October 5, 2018

Champlain Tower South Condominium
8777 Collins Avenue
Surfside, FL 33154

**Re: Champlain Towers South Condominium
Structural Field Survey Report
MC Job# 18217**

Figure E: Deteriorated plywood soffit above entrance drive.

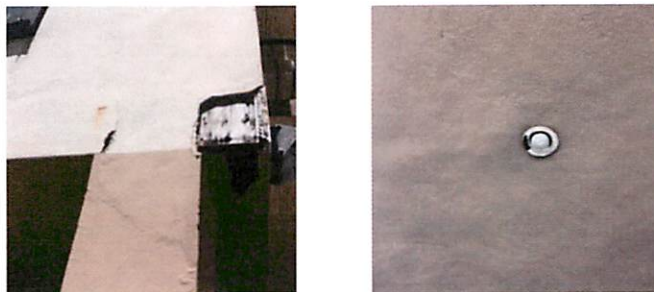
- E. Several areas of the entrance drive soffits under the second floor were observed by MC to have deteriorated black plywood. This condition was also observed at several light fixtures in the entrance soffit. MC could not get access into the soffit areas to observe the extent of the deteriorated soffits and support framing as CTS maintenance was too busy to assist us. MC is concerned that mold exists above these soffit areas and the soffit support framing is deteriorated which will require the complete removal and replacement of the entrance suspended soffit. Further investigation into this area is warranted.

Figure G: Typical cracking in the stucco exterior facade.

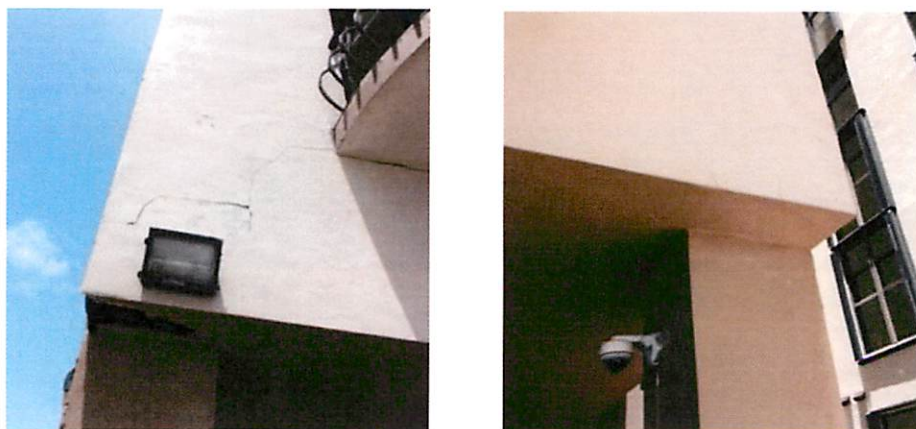
- G. Significant cracking in the stucco exterior façade often occurs at the mortar bed joint between the top of the concrete floor slab and first block masonry course. Although MC does not see this crack as a source of water infiltration into the condominium units, such cracks need to be routed and repointed to prevent future water permeation. All significant façade stucco cracking is to be repaired in accordance with the recommendations of ICRI.

Figure K1: Previously installed failed injection repairs with leaching forming

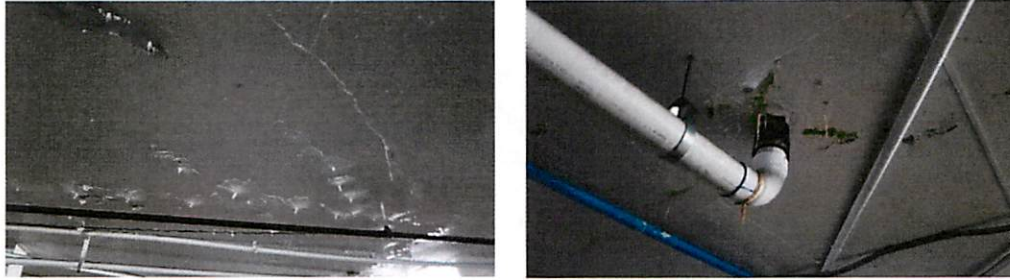
- K. MC visual observations revealed that many of the previous garage concrete repairs are failing resulting in additional concrete cracking, spalling and leaching of calcium carbonate deposits. At the underside of Entrance/Pool deck where the slab had been epoxy-injected, new cracks were radiating from the originally repaired cracks. The installed epoxy is not continuous as observed from the bottom of the slab, which is evidence of poor workmanship performed by the previous contractor. The injection ports were not removed, and the surfaces were not ground smooth at the completion of the injection. Leaching of calcium carbonate deposits in numerous areas has surely caused CTS to pay to repaint numerous cars. This leaching will continue to increase until proper repairs are completed. MC is convinced that the previously installed epoxy injection repairs were ineffective in properly repairing the existing cracked and spalled concrete

slabs. MC recommends that the Entrance/Pool deck concrete slabs that are showing distress be removed and replaced in their entirety. Unfortunately, all of these failed slab areas are under brick pavers, decorative stamped concrete and planters which require completed waterproofing replacement. All repaired concrete slabs located in the parking garage are to be repaired in accordance with the recommendations of ICRI.
